TOLEDO - LUCAS COUNTY PLAN COMMISSIONS

REF: SUP-12002-22

SUBJECT: Special Use Permit for a Day Care Center at 1822 Upton Avenue

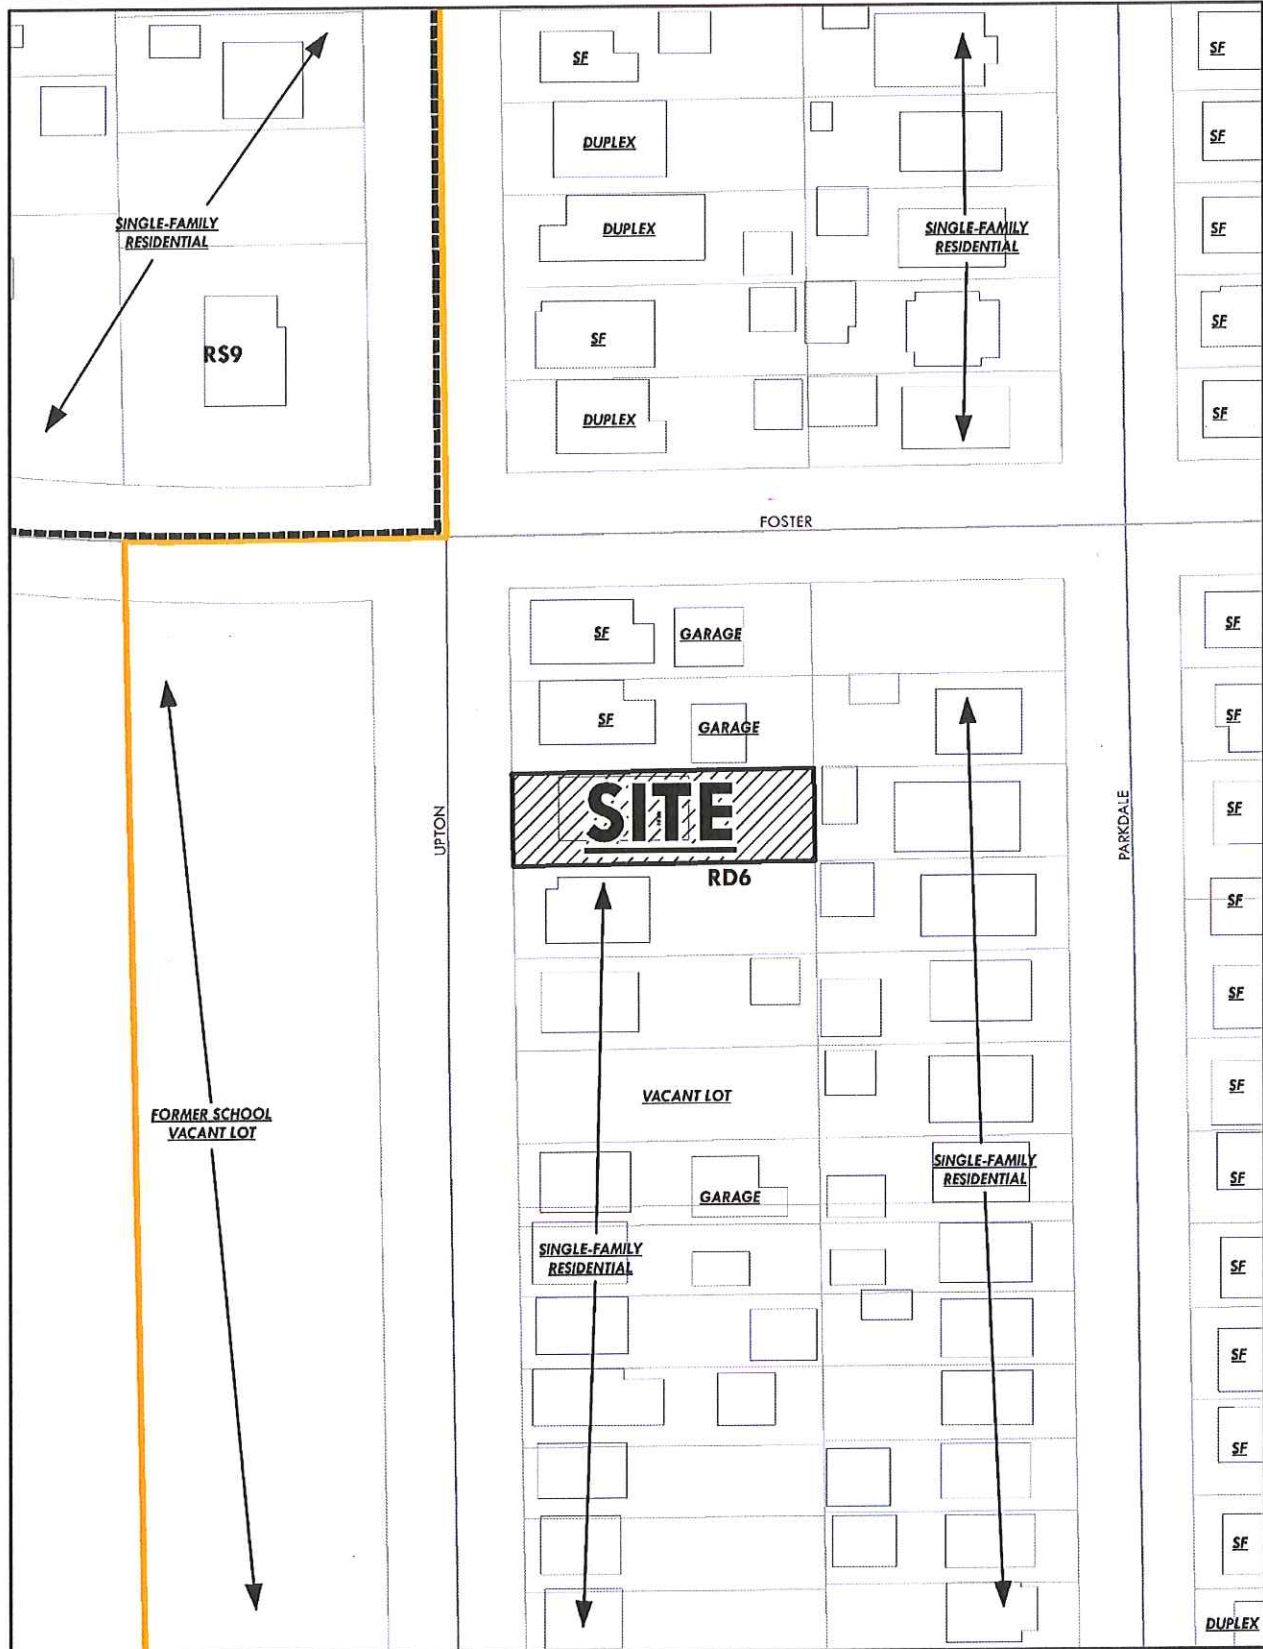
20. Per TMC§1107.0304 a Day Care Center is required to have one (1) parking space per six (6) person-capacity or one (1) parking space per 400 square feet, whichever is greater. A total of three (3) parking spaces are required for the site. The site plan submitted depicts an area available for three (3) parking spaces stacked on a single vehicle width driveway. **Not acceptable as depicted.**

21. A cross-access easement and/or a shared-parking easement shall be recorded for the adjacent driveway at 1818 Upton Avenue to be used as parking.
22. Any spaces reserved for the use by persons with physical disabilities shall adhere to the standards outlined in TMC§1107.1700. One (1) van accessible space is required. **Not acceptable as depicted. One (1) van accessible space shall be shown on a revised site plan.**

23. Per TMC§1107.0400, Off-Street Parking Schedule "A" requires one (1) bicycle parking slot per ten (10) parking spaces. **Not acceptable as depicted. One (1) bicycle parking space is required and shall be depicted on a revised site plan.**

24. Per TMC§1107.1202, no parking space may be located within the front yard, except that parking spaces for detached houses, attached houses, and duplexes may be located on a driveway. **Not acceptable as depicted. The proposed 20'x5' concrete pad in front of the house is not permitted to be used as parking.**
